RENESAS TECHNICAL UPDATE

Product Category	MPU/MCU	Document No.	TN-SH7-A883A/E	Rev.	1.00
Title	Correction of errors regarding the SRAM Interface on Internal Bus of the Bus State Controller (BSC)		Information Category	Technical Notification	
Applicable Product	<ul style="list-style-type: none"> • SH7214 Group • SH7216 Group 	Lot No.	Reference Document	<ul style="list-style-type: none"> • SH7214 Group, SH7216 Group User's Manual: Hardware Rev.4.00 (R01UH0230EJ0400) 	
		All lots

Figure 9.41 Example of Connection with 16-Bit Data-Width SRAM with Byte Selection

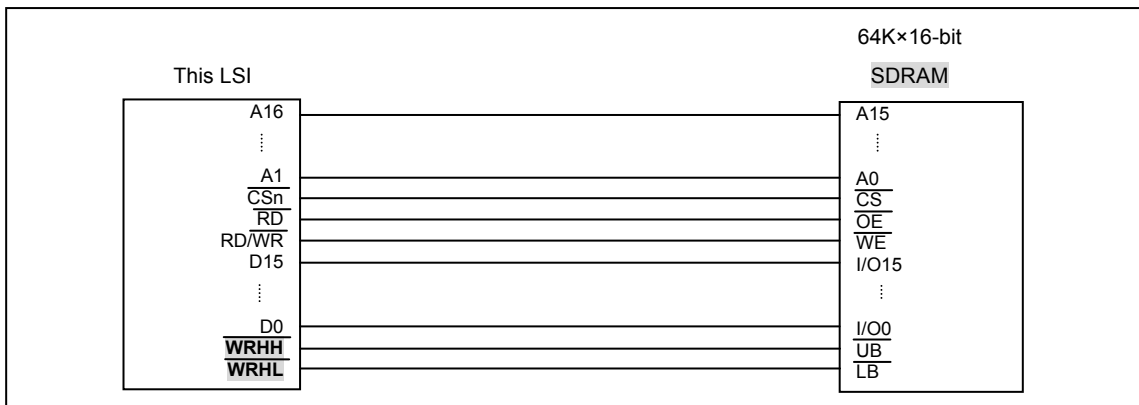
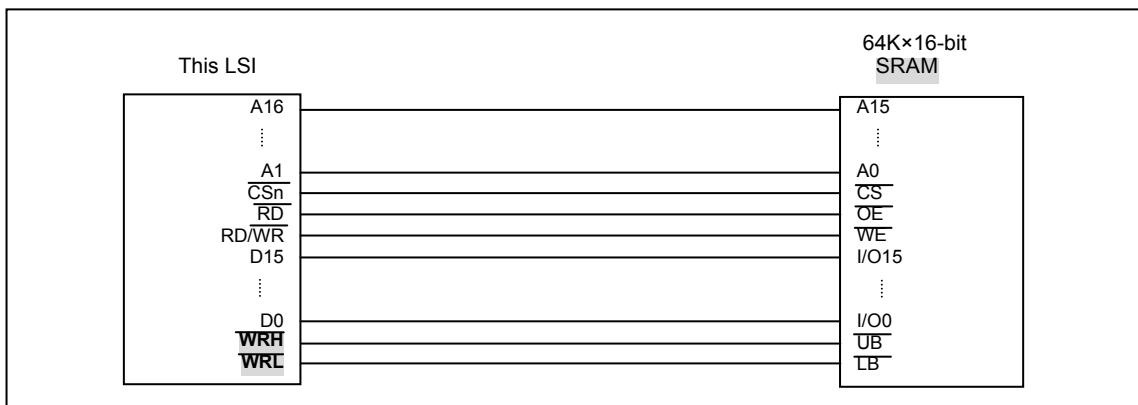
<Corrections>

9.5.8 SRAM Interface with Byte Selection

Erroneous:

Corrected:
